**CITY OF WEST LINN
PLANNING COMMISSION PUBLIC HEARING
DATE: MARCH 4, 2009**

FILE NO.: DR-09-01/MIS-09-01

REQUEST: CONVERSION OF NON-CONFORMING STRUCTURE,
WHICH IS A HISTORIC LANDMARK HOME, TO OFFICE
AT 4835 WILLAMETTE FALLS DRIVE, REQUIRING
CLASS I DESIGN REVIEW AND PERMIT TO
ENLARGE/ALTER A NON-CONFORMING STRUCTURE

**City of West Linn
PLANNING & DEVELOPMENT
STAFF REPORT**

SITE PLAN • 4835 SW Willamette Falls Drive
Storm Drainage system

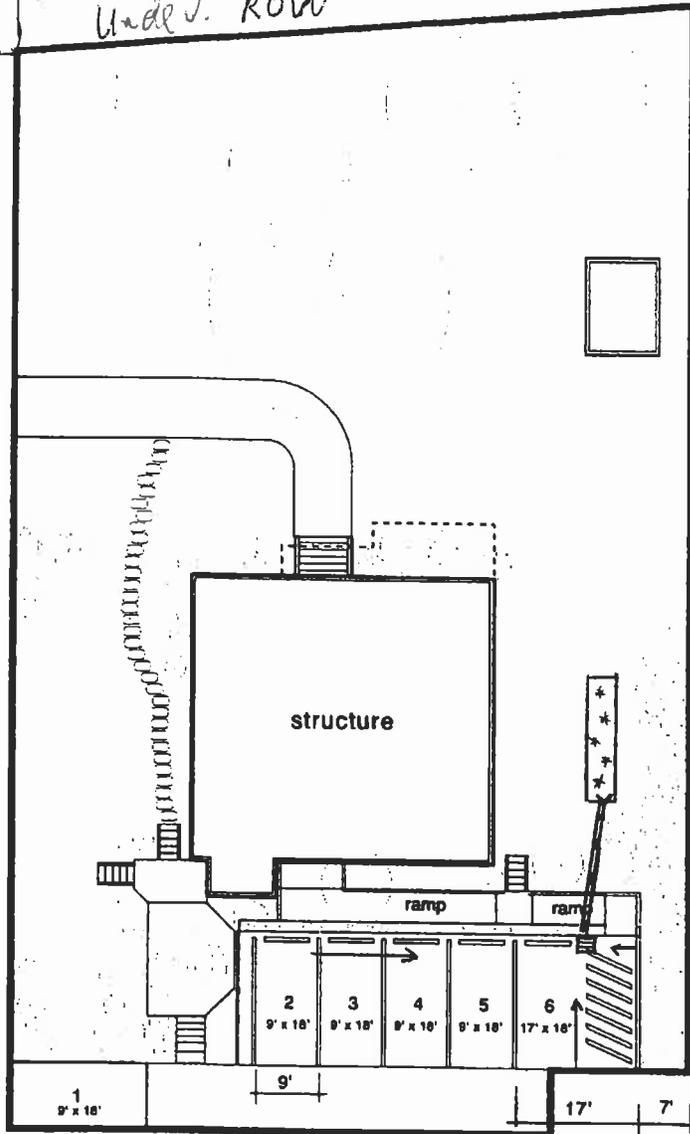
With the catch basin and rain garden showing on the site plan, the applicant has completed all the requirements from the Engineering Department.

-  - Rain Garden/Infiltration
6% impermeable surface Area
-  - Catch Basin @ Low Point
Grade Parkings to Drain
-  - PVC storm pipe
Daylight @ Rain Garden

SITE PLAN • 4835 SW Willamette Falls Drive

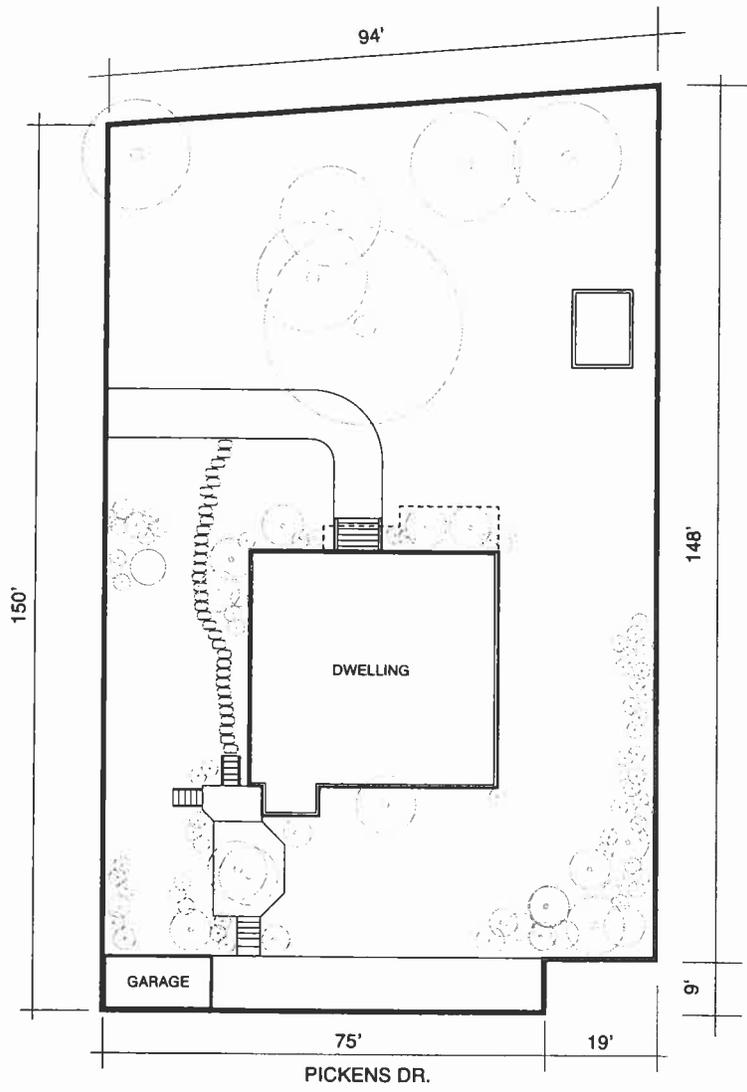
Site plan is provided in attachment. Upon approval we will be in contact with the Shaun Rohret and our intentions are to find a water permeable surface vs. asphalt should the parking lot be approved.

- CDC Chapter 46.150 Design Standards
- The attached parking plan was developed using the design standards in Chapter 46. There are a total of 6 spots that measure 9 x 18 and a Handicap spot measuring 17 x 18.
